CITY AIRPORT DEVELOPMENT PROGRAMME (CADP)

# CADP: ENVIRONMENTAL STATEMENT ADDENDUM

INCLUDING FURTHER  
INFORMATION UNDER  
EIA REGULATION 22

4 March 2014

**Figure 4.1 – Image showing ground noise prediction model receptors**

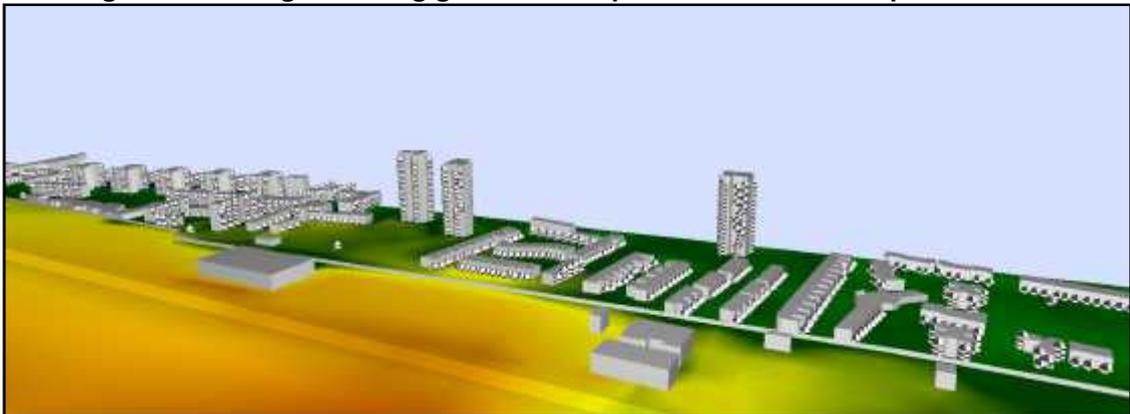
**Response:**

- 4.49 There are many low, medium and high rise flats to the south of the Airport. To provide a representative assessment of ground noise levels in the local communities, a substantial number of assessment locations have been used (around 2,400). These include receptors at all floor heights, as shown in Figure 4.1. This is a view of the Silvertown/ North Woolwich area. It is presented to show the heights of the receptor points (black and white spheres) which can be seen in front of the buildings.

- 4.50 To provide more information as requested, ground noise contours have also been produced at 5 dB bands for 3rd floor, 6th and 9th floor receivers. The 3rd and 6th floor receiver locations are representative of apartment windows in the Woodman Street, Camel Road and UEL areas. The 9th floor receivers are representative of higher floors in the Dunedin, Westland and Queensland Houses. These are the three tower blocks visible in Figure 4.1. The resulting ground noise contours are provided in Appendix 4.4 of this ES Addendum.
- 4.51 These illustrate the predicted absolute ground noise levels at higher levels. An objective assessment of ground noise at all representative receiver heights was presented in the ES.

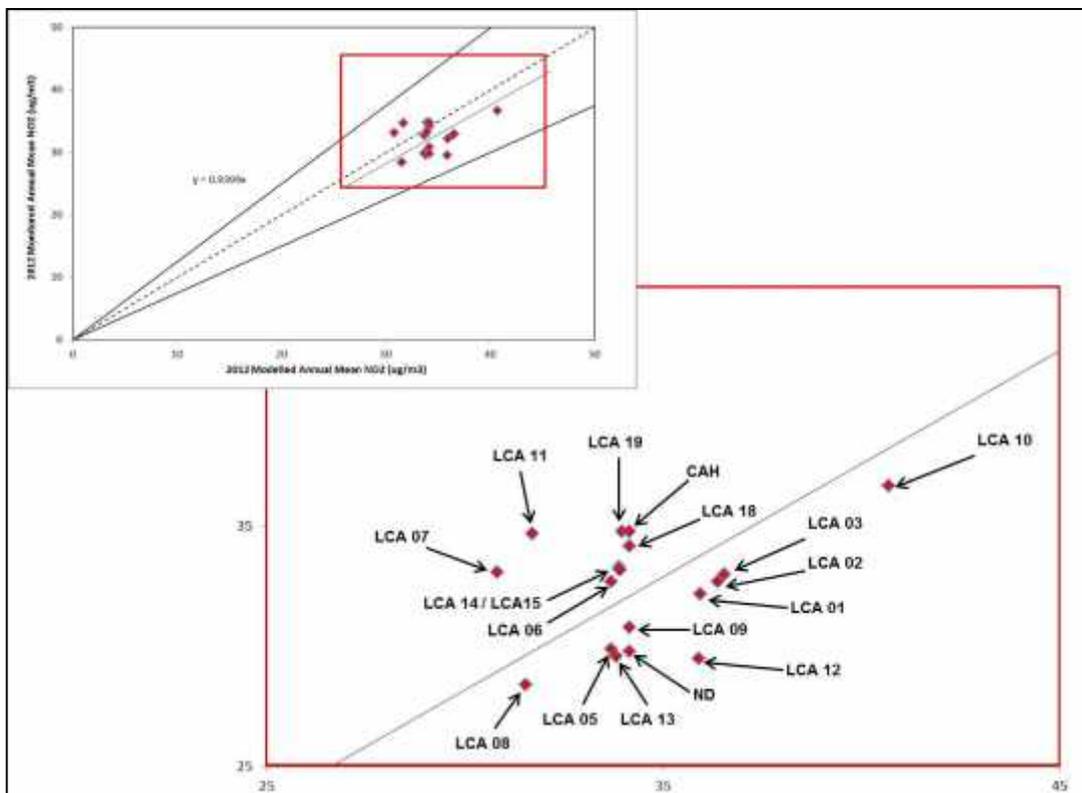
34) The overall approach adopted for model verification is accepted, although the adjustment factor could be affected by the choice of monitoring sites included in the analysis. It is not clear which data points in Figure 9.4 relate to which monitoring sites, or whether they are locations relevant in terms of exposure. Further clarification is sought to provide confidence that the modelled concentrations are not under-predicted at locations of relevant exposure beyond the airport boundary.

- 5.29 ES Chapter 9, Figure 9.4 is reproduced below with each data point labelled to indicate the monitoring location. This should be compared with Table 9.9 in Chapter 9 of the ES, which describes each monitoring location

- 5.30 The principal locations of relevant exposure beyond the Airport boundary include the properties to the south (LCA1, LCA2, LCA8) and to the north (LCA5, LCA6). For the majority of these data points the figure above indicates that the model is over-predicting annual mean nitrogen dioxide concentrations.
